IOWA STATE UNIVERSITY

AMENDMENT TO FACILITY OPERATING LICENSE

Amendment No. 9
License No. R-59

ENCLOSURE TO LICENSE AMENDMENT NO. 9

Figure 6-1. Organization structure

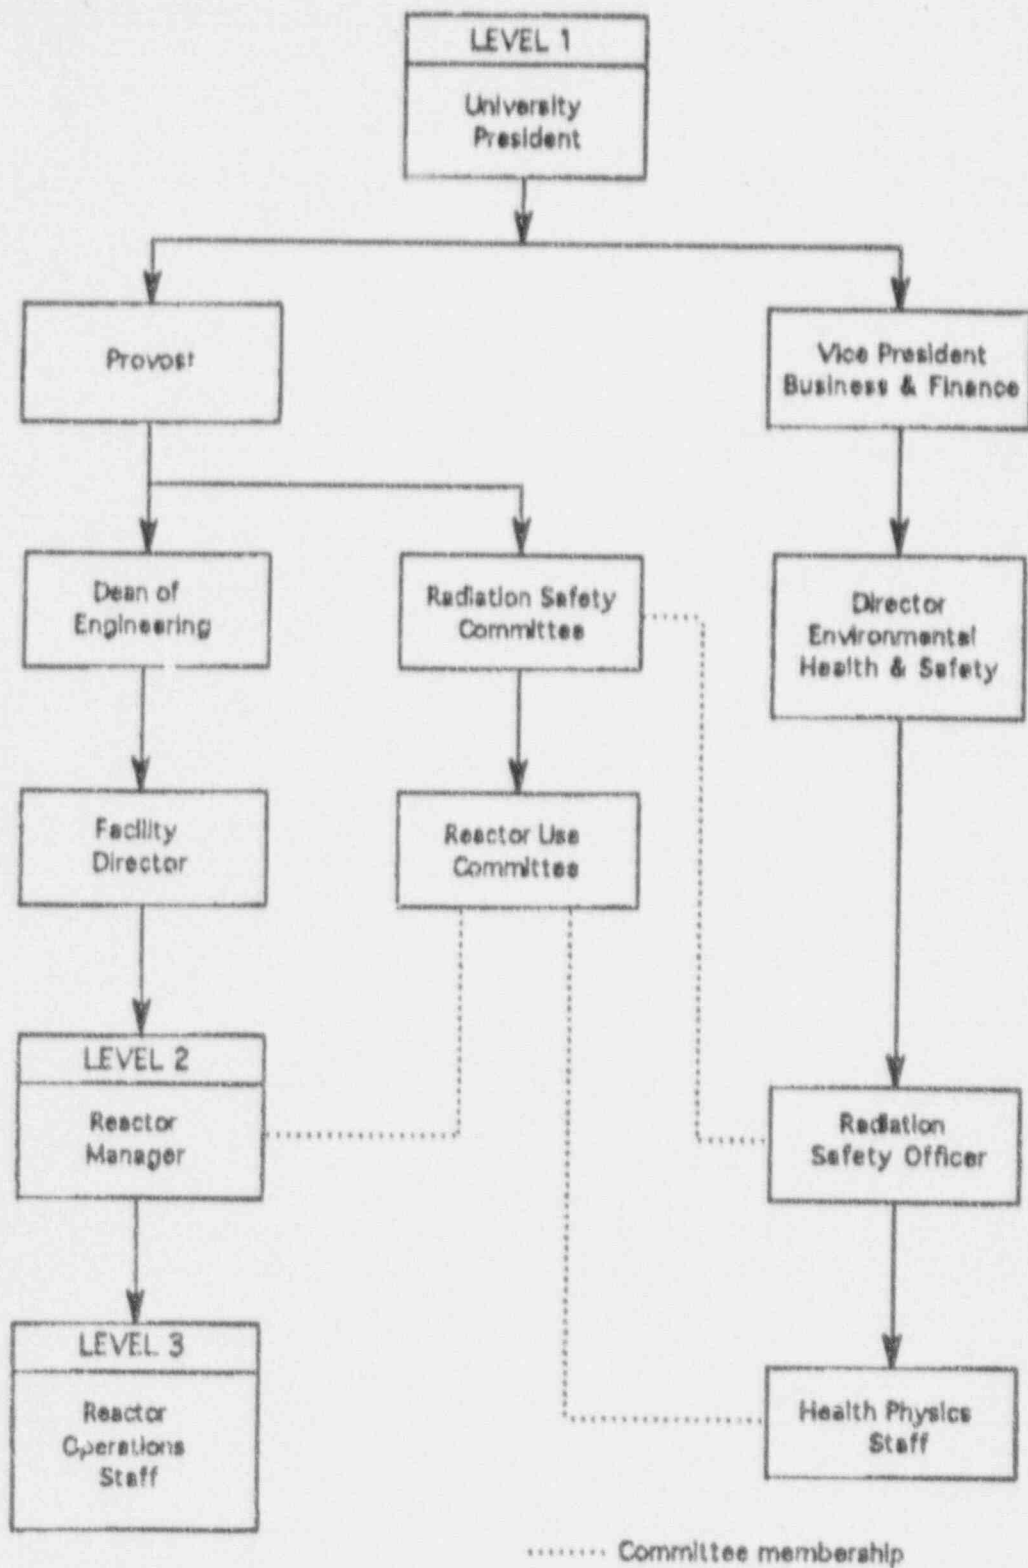
Replace Section 6 of the Appendix A Technical Specification pages 6-1 through 6-17 and Figure 6-1 with pages 6-1 through 6-11. The revised pages are identified by amendment number and the changes are underlined. The Technical Specifications (TS) have been retyped in their entirety which results in new page numbers for the same paragraphs in the previous TS. However, the paragraph numbers have not changed.

The organization for the management of the reactor facility shall be structured as indicated in Figure 6-1. Job titles are shown for illustration and may vary. Levels of authority indicated divide responsibility as follows:

- Level 1: Responsible for the facility license and site administration.
- Level 2: Responsible for the reactor facility operation and management.
- Level 3: Responsible for daily operations.

The Reactor Use Committee is appointed by, and shall report to the University Radiation Safety Committee. Radiation safety personnel shall report to Level 2 or higher through an independent organizational channel.

The Facility Director shall be responsible for the facility license and site administration. The dean, College of Engineering, shall appoint persons, qualified in accordance with paragraph 6.1.4, to the Facility Director and Reactor Manager positions.

Individuals at the various management levels shown in Figure 6-1, in addition to having responsibility for the policies and operation of the facility, shall be responsible for safeguarding the public and facility personnel from undue radiation exposures and for adhering to all requirements of the Operating License and the Technical Specifications.
